RE: Recall Number 06V-445 Defect Information Report (additional information)  
(Hyundai Campaign 079)

FROM:      Hyundai Motor America  
SUBJECT:      **Campaign 079 - 2005-2007 Tucson - Driver Airbag Replacement**

**SUBJECT: Campaign 079 - 2005 - 2007 Tucson - Driver Airbag Cover Module Replacement**

Subject	TUCSON DRIVER AIR BAG COVER MODULE REPLACEMENT (CAMPAIGN 079)
---------	---

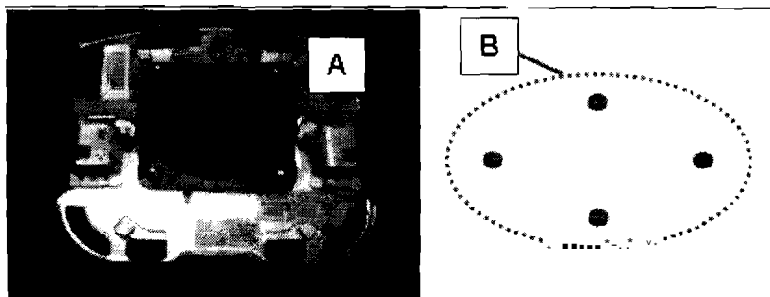
3. The new DAB cover module includes the black plastic air bag inflator opening shipping protection cover (A) and four inflator mounting nuts (B) only. It does not include the inflator. Therefore, the existing inflator must be re-installed onto the new DAB cover module. Refer to the following Service Procedure.
